Extra

May 11, 1994

SUBJECT: Revisions to Construction Standards

Several changes are being made to existing Construction Standard Drawings and the Construction Standards Index.

DESIGN APPROVED	STATE OF ARIZONA DEPARTMENT OF TRANSPORTATION DIVISION OF HIGHWAYS STANDARD DRAWINGS	REV. 3/94
APPROVED FOR DISTRIBUTION	DITCHES, CHANNELS, DIKES AND BERMS DIKES	DRAWING NO. C-03.10 Sheet 2 of 5

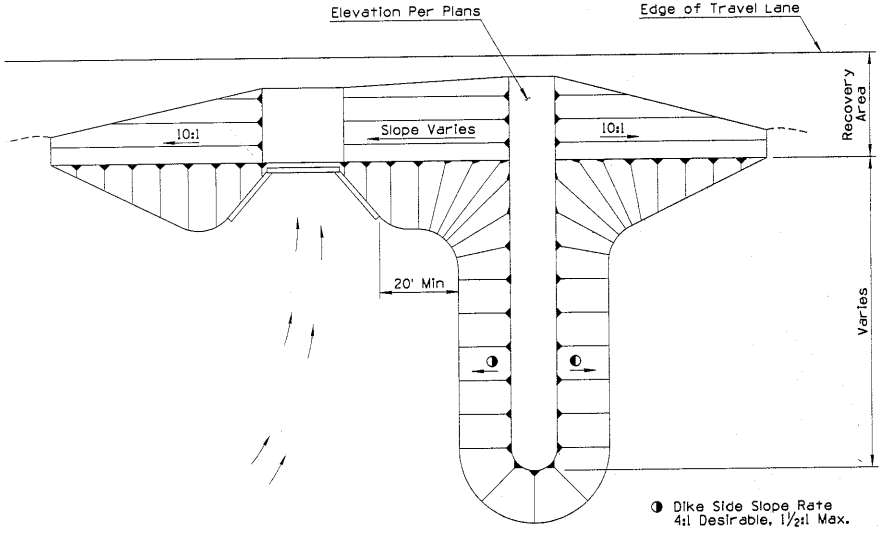
REVISED DRAWING	**REVISION**
C-03.10 Ditches, Channels, Dikes & Berms	Deleted old note 4 that referred to a non-existant standard. Corrected spelling of "dyke". Added slope rounding to crown and grader ditch details. Added a callout for profile grades on channels with a bottom width more than 10'. Expanded standard: ditches and channels on one sheet and dikes on another. Added items frequently used as details: ditch dikes, pipe berms, headwall berms. Fixed dike slopes within clear zone or "recovery area" at 10:1. Added a perspective view of a typical median dike installation.
C-05.30 Sidewalk Ramps	Type 1 - Added note indicating 4' minimum bottom width, as per ADA. Types 2 & 4 - Added note indicating that for curb heights over 7" to see plans. Modified note indicating that for curb heights under 6" to use values shown for 6" high curb.

NO.	DESCRIPTION OF REVISIONS	MADE BY	DATE
1	MODIFIED SLOPE	PNB	3/94
2	MODIFIED INSTALLATION DETAIL	PNB	3/94
3	ADDED PERSPECTIVE VIEW	PNB	3/94
4

DESIGN APPROVED	STATE OF ARIZONA DEPARTMENT OF TRANSPORTATION DIVISION OF HIGHWAYS STANDARD DRAWINGS	REV. 3/94
APPROVED FOR DISTRIBUTION	SIDEWALK RAMP TYPE 1	DRAWING NO. C-05.30 Sheet 1 of 4

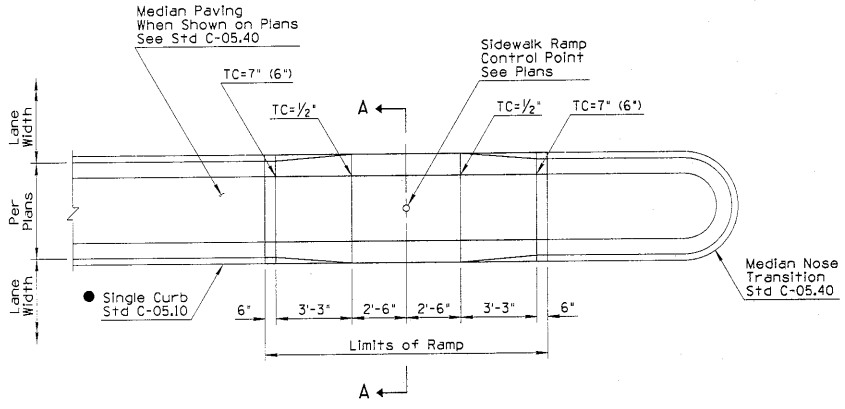
NO	DESCRIPTION OF REVISIONS	MADE BY	DATE
1	ADDED NOTE	PNB	3/94
2			
3			
4

1. Top of curb (TC) and top of ramp elevations shown are in relation to the gutter. Gutter=0".
2. See Std C-05.10, C-05.11 and C-05.20 for joint requirements.
3. When curb heights of 6" are shown on plans, use dimensions shown in ( )'s.
4. If field modification is required, bottom width shall be 4' minimum, as per ADA requirements.

DESIGN APPROVED	STATE OF ARIZONA DEPARTMENT OF TRANSPORTATION DIVISION OF HIGHWAYS STANDARD DRAWINGS	REV. 3/94
APPROVED FOR DISTRIBUTION	SIDEWALK RAMP TYPE 2	DRAWING NO. C-05.30 Sheet 2 of 4

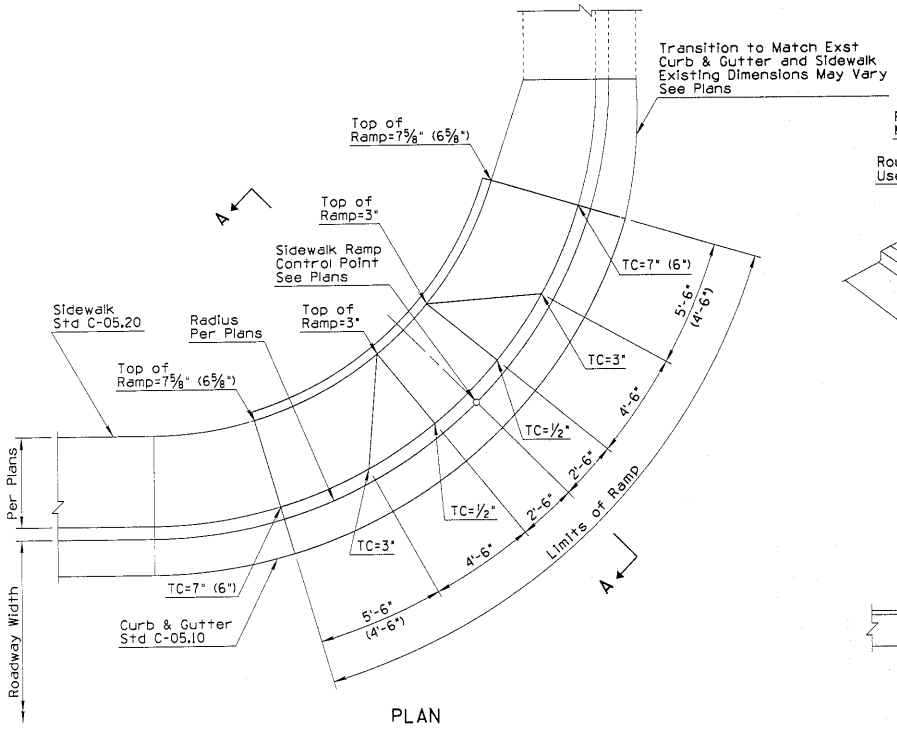
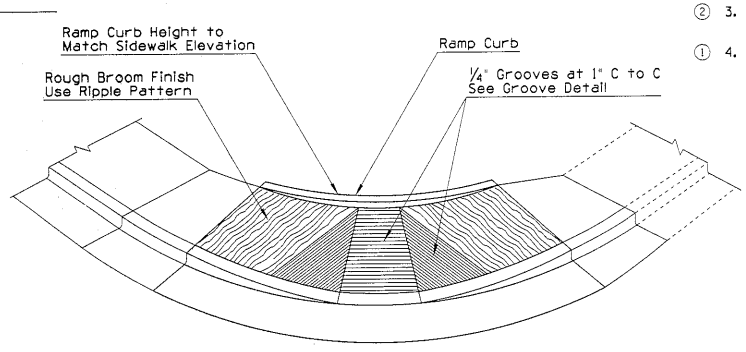
NO	DESCRIPTION OF REVISIONS	MADE BY	DATE
1	ADDED NOTE	PNB	3/94
2	MODIFIED NOTE	PNB	3/94
3			
4

1. Top of curb (TC) and top of ramp elevations shown are in relation to the gutter and are located radially. Gutter=0".
2. See Std C-05.10, C-05.11 and C-05.20 for joint requirements.
3. (2) When curb heights of 6" or less are shown on plans, use dimensions shown in ( )'s.
4. (1) When curb heights of 7" or more are shown on plans, see plans and ADA requirements.

DESIGN APPROVED APPROVED FOR DISTRIBUTION	STATE OF ARIZONA DEPARTMENT OF TRANSPORTATION DIVISION OF HIGHWAYS STANDARD DRAWINGS	3/94
	(1) SIDEWALK RAMP TYPE 4	DRAWING NO. C-05.30 Sheet 4 of 4

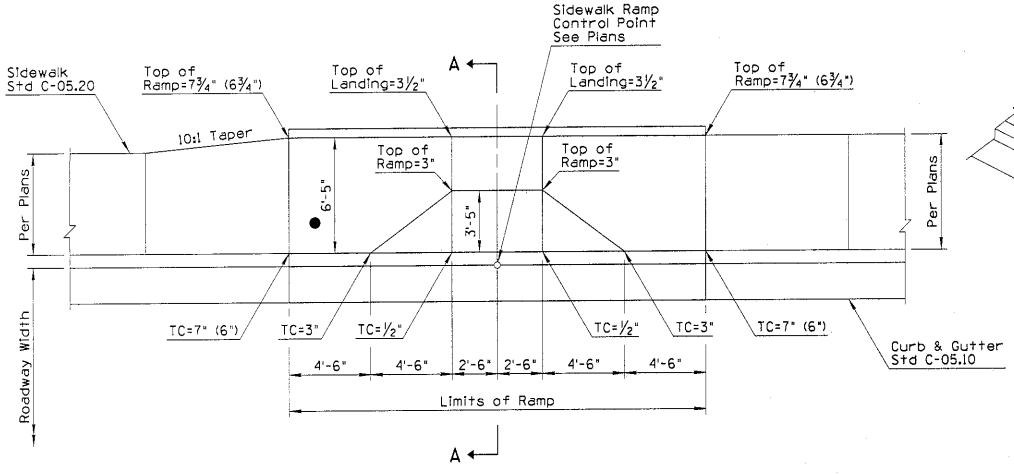
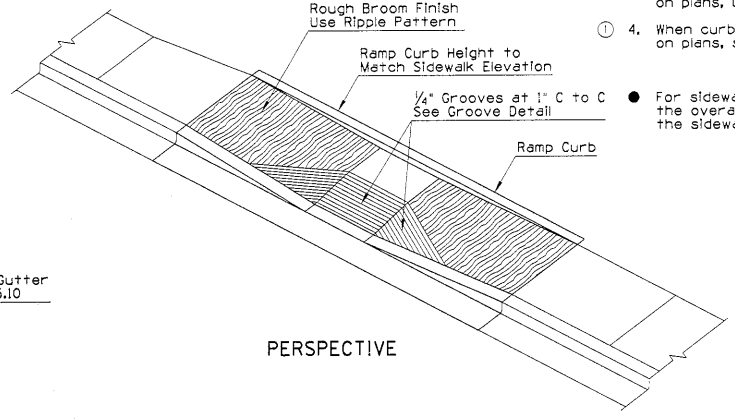
NO	DESCRIPTION OF REVISIONS	MADE BY	DATE
1	ADDED NOTE	PNB	3/94
2	MODIFIED NOTE	PNB	3/94
3			
4

1. Top of curb (TC) and top of ramp elevations shown are in relation to the gutter. Gutter=0".
2. See Std C-05.10, C-05.11 and C-05.20 for joint requirements
3. (2) When curb heights of 6" or less are shown on plans, use dimensions shown in ( )s.
4. (1) When curb heights of 7" or more are shown on plans, see plans and ADA requirements.

DESIGN APPROVED	STATE OF ARIZONA DEPARTMENT OF TRANSPORTATION DIVISION OF HIGHWAYS STANDARD DRAWINGS	3/94
APPROVED FOR DISTRIBUTION	PCCP JOINTS	DRAWING NO. C-07.01 Sheet 2 of 2

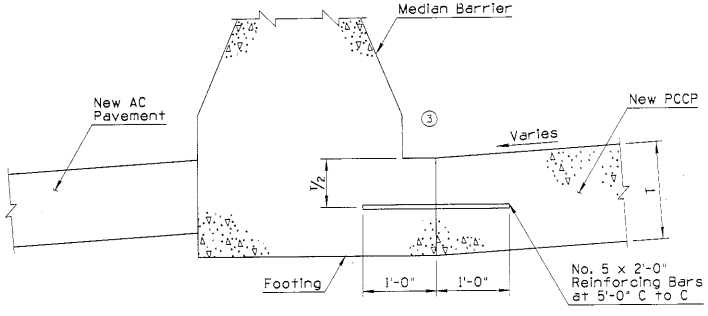
REVISED DRAWING	REVISION
C-07.01 PCCP Joints	Revised median barrier joint to show all PCCP. Revised median barrier joint to show AC and PCCP and revised the joint. Added note on pavement cross slope.
C-10.28 Nested Steel W Beam	New standard replaces old buried anchor portions of old Stds C-10.23 & C-10.24.
C-10.29 Bolted Anchor Guard Rail	New standard from bolted anchor portions of old Stds C-10.23 & C-10.24
C-10.30 Guard Rail Transition W Beam to Half Barrier (Approach)	New standard from portions of old Stds C-10.25, C-10.30, & C-10.35. Removed all but first two rectangular plate washers. For steel posts, changed the W structural shape blockouts on the first two posts to 6"x6" tube.
C-10.31 Guard Rail Transition W Beam to Half Barrier (Appr.)(Curb)	New standard from portions of old Stds C-10.25, C-10.30, & C-10.35. Removed all but first two rectangular plate washers. For steel posts, changed the W structural shape blockouts on the first two posts to 6"x6" tube. Added rub rail. Added 25' of Nested (additional) Steel W Beam.

NO.	DESCRIPTION OF REVISIONS	MADE BY	DATE
1	REVISED DETAIL TO SHOW ALL PCCP	PNB	3/94
2	REVISED DETAIL TO SHOW AC & PCCP	PNB	3/94
3	DELETED EXPANSION MATERIAL	PNB	3/94
4	ADDED NOTE ON PAVEMENT SLOPE	PNB	3/94

(4) 1. Joints are generally shown with pavement sloping toward the joint. Joints are similar with pavement sloping away from the joint.

DESIGN APPROVED APPROVED FOR DISTRIBUTION	STATE OF ARIZONA DEPARTMENT OF TRANSPORTATION DIVISION OF HIGHWAYS STANDARD DRAWINGS	3/94
	1 NESTED STEEL W BEAM SHORT SPAN - TYPE 1 AND 2	DRAWING NO. C-10.28 Sheet 1 of 2

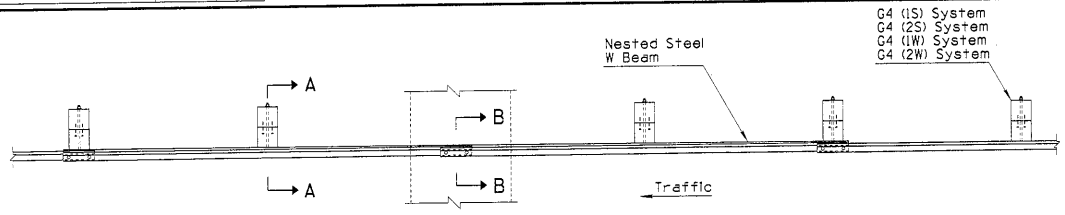
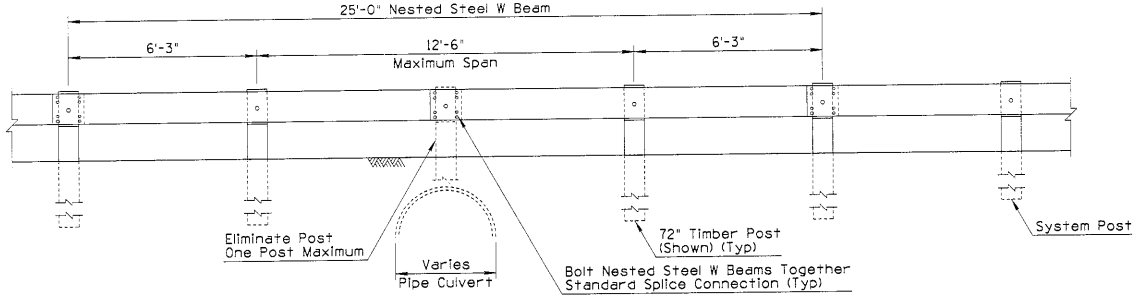
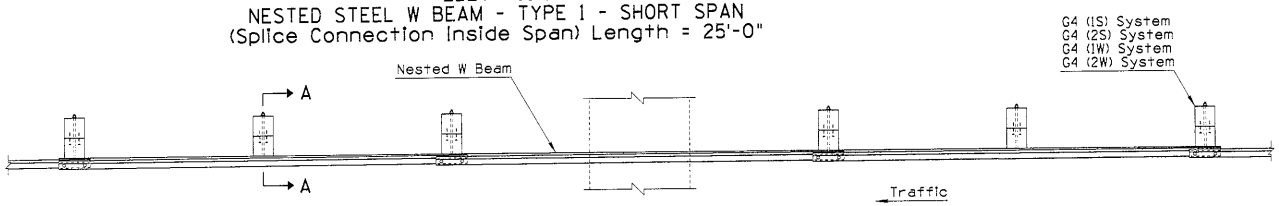
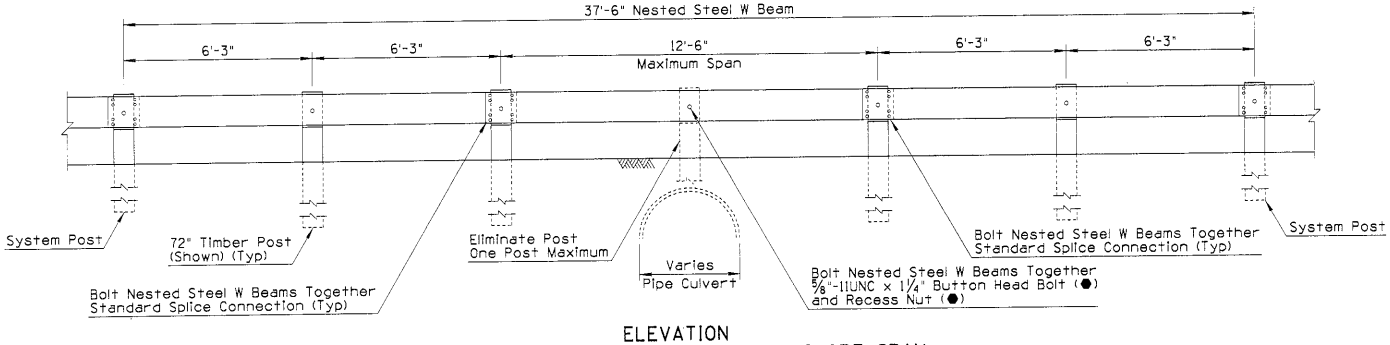
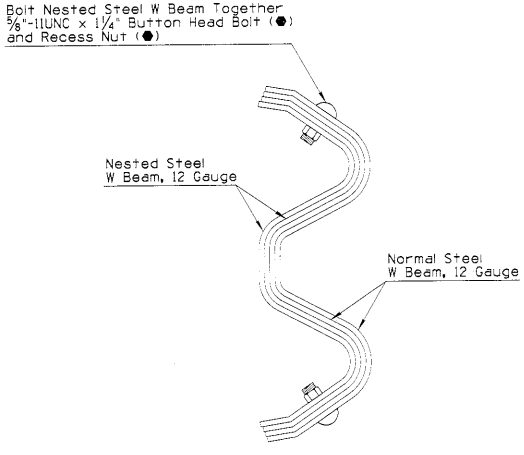
NO	DESCRIPTION OF REVISIONS	MADE BY	DATE
1	NEW STD FROM C-10.23 & C-10.24	PNB	3/94
2			
3			
4

DESIGN APPROVED	STATE OF ARIZONA DEPARTMENT OF TRANSPORTATION DIVISION OF HIGHWAYS STANDARD DRAWINGS	3/94
APPROVED FOR DISTRIBUTION	1 NESTED STEEL W BEAM LONG SPAN - TYPE 3	DRAWING NO. C-10.28 Sheet 2 of 2

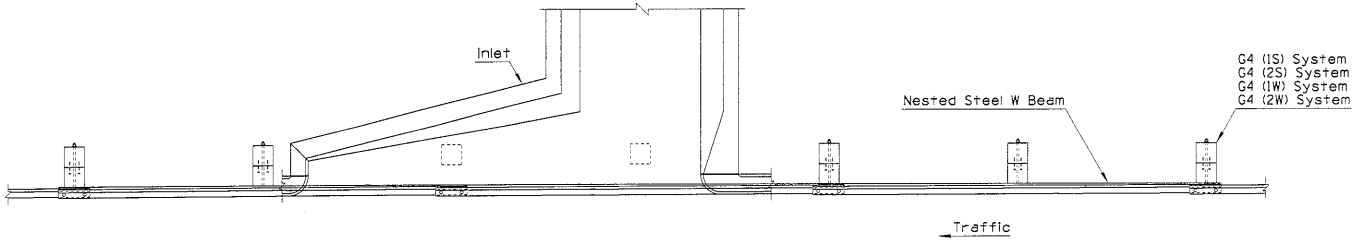
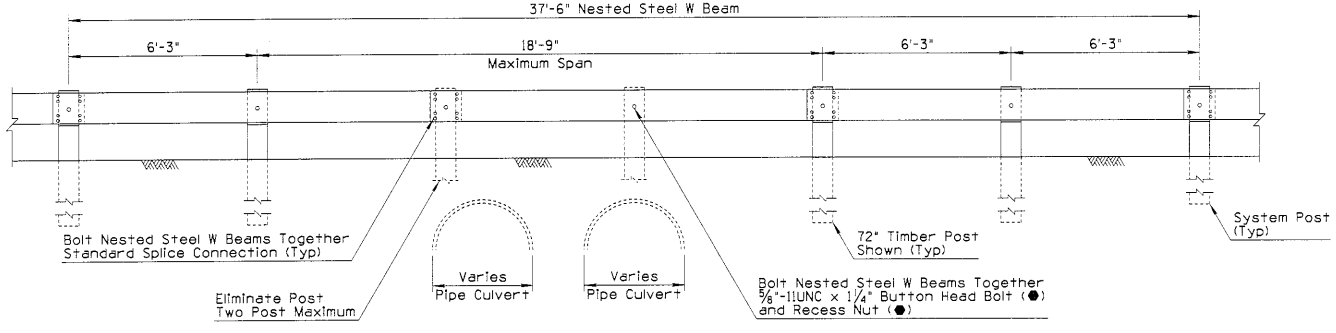
NO.	DESCRIPTION OF REVISIONS	MADE BY	DATE
1	NEW STD FROM C-10.23 & C-10.24	PNB	3/94
2			
3			
4

DESIGN APPROVED Terry H. Otterness	STATE OF ARIZONA DEPARTMENT OF TRANSPORTATION DIVISION OF HIGHWAYS STANDARD DRAWINGS	3/94
APPROVED FOR DISTRIBUTION	① BOLTED ANCHOR GUARD RAIL	DRAWING NO. C-10.29 Sheet 1 of 2

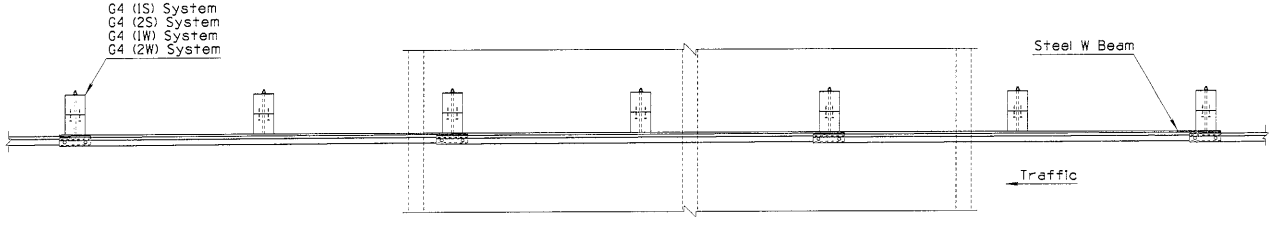
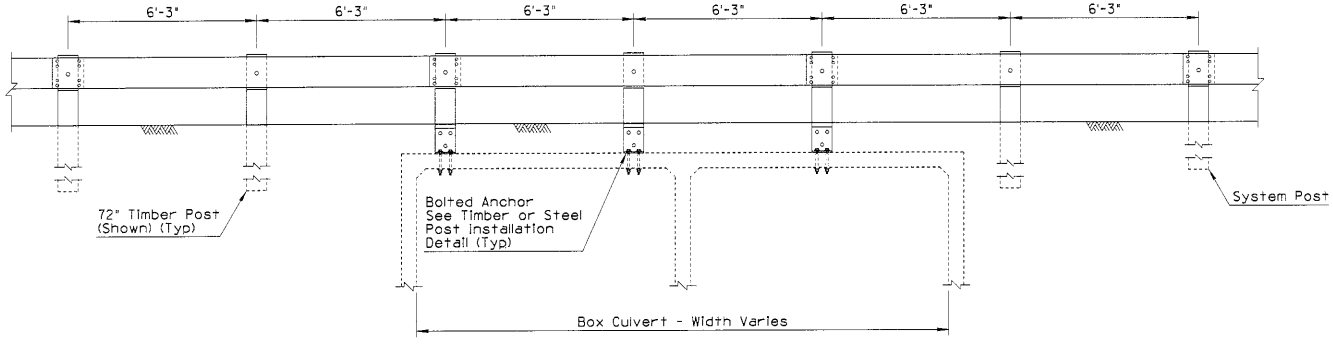
NO	DESCRIPTION OF REVISIONS	MADE BY	DATE
1	NEW STD FROM C-10.23 & C-10.24	PNB	3/94
2			
3			
4

DESIGN APPROVED Terry H. Otterness	STATE OF ARIZONA DEPARTMENT OF TRANSPORTATION DIVISION OF HIGHWAYS STANDARD DRAWINGS	3/94
APPROVED FOR DISTRIBUTION (1)	BOLTED ANCHOR GUARD RAIL	DRAWING NO. C-10.29 Sheet 2 of 2

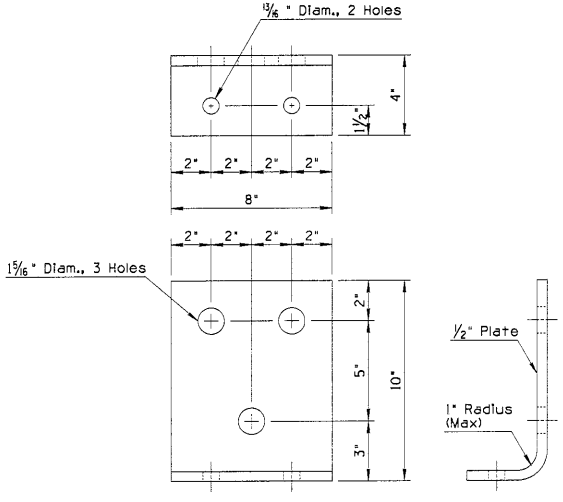
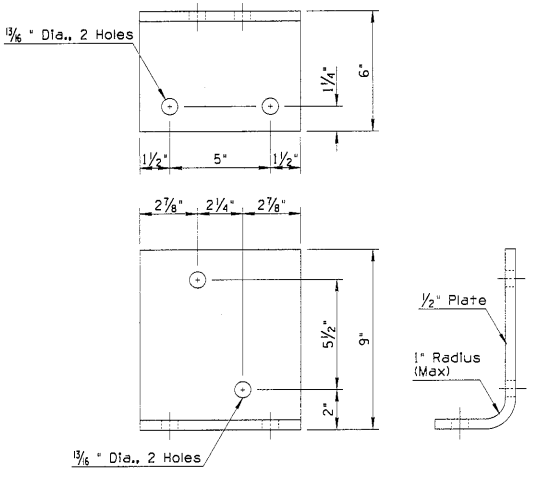
NO.	DESCRIPTION OF REVISIONS	MADE BY	DATE
1	NEW STD FROM C-10.23 & C-10.24	PNB	3/94
2			
3			
4

DESIGN APPROVED	STATE OF ARIZONA DEPARTMENT OF TRANSPORTATION DIVISION OF HIGHWAYS STANDARD DRAWINGS	3/94
APPROVED FOR DISTRIBUTION	CONCRETE HALF BARRIER TRANSITION	DRAWING NO. C-10.70 Sheet 1 of 4

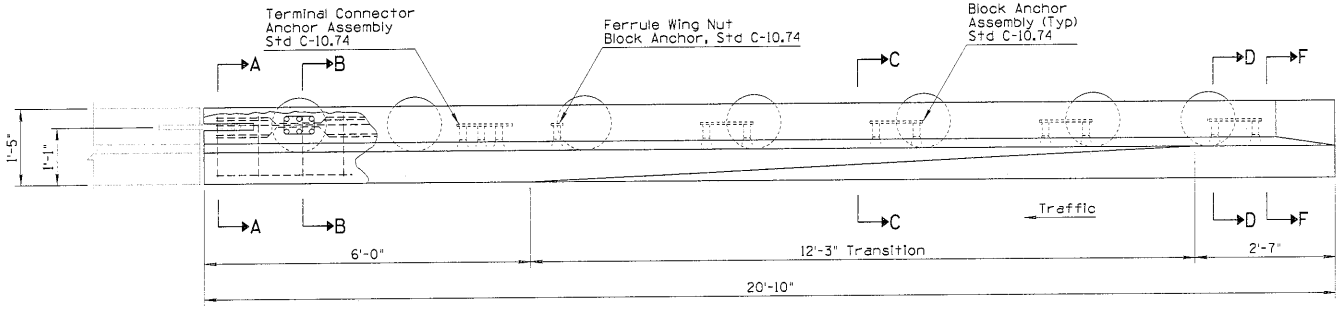
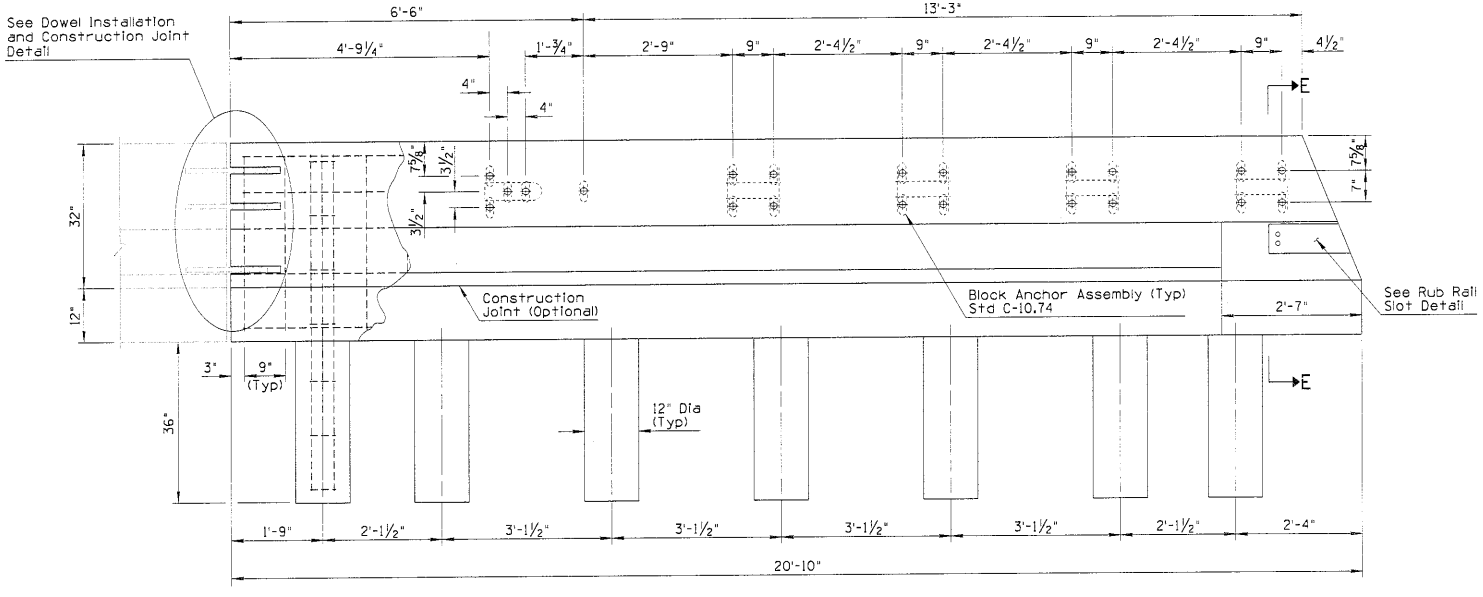
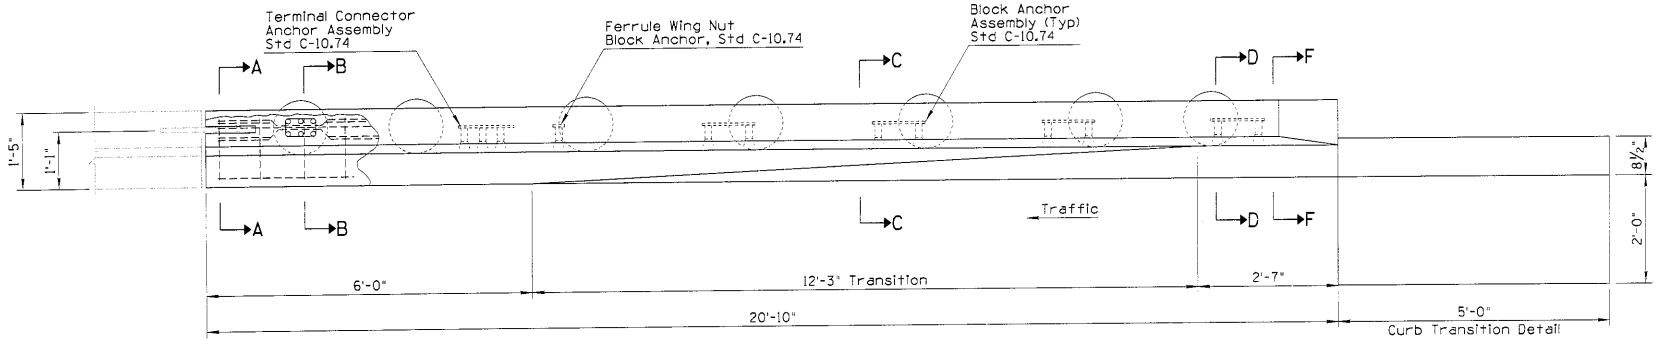
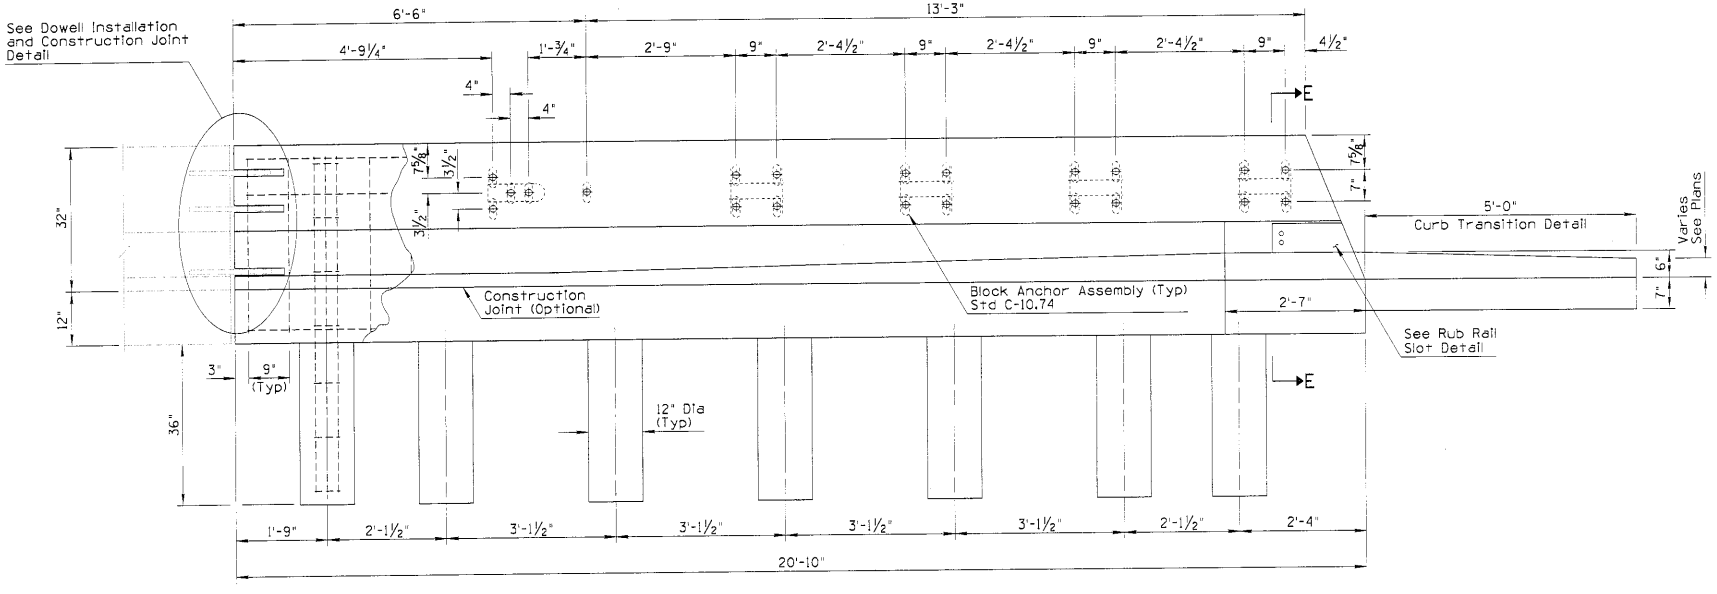
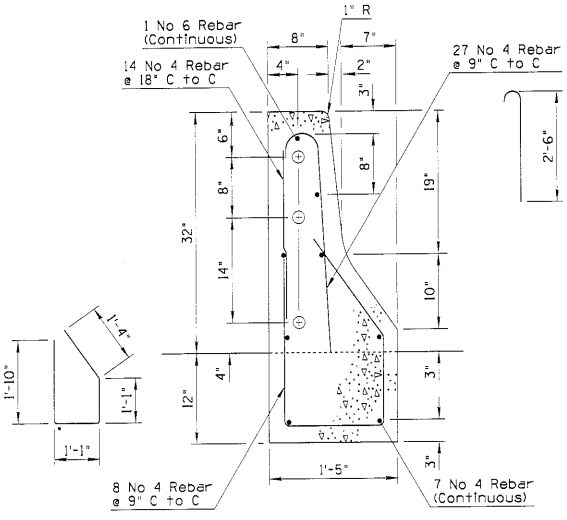
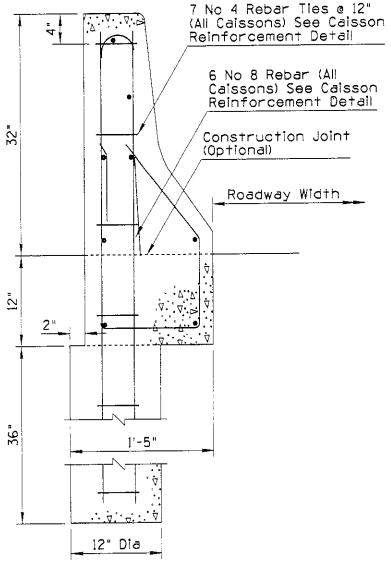
C-10.32 Guard Rail Transition W Beam to Half Barrier (Departure)	New standard.
C-10.39 Hardware for W Beam Transition to Concrete Barrier	New standard.
C-10.70 Concrete Half Barrier Transition	New standard from portions of old Stds C-10.25, C-10.30, & C-10.35. Revised shape of end of transition to that of bridge concrete barrier transition. Changed the long bolt holes to embedded anchors as per Std B-21.21.
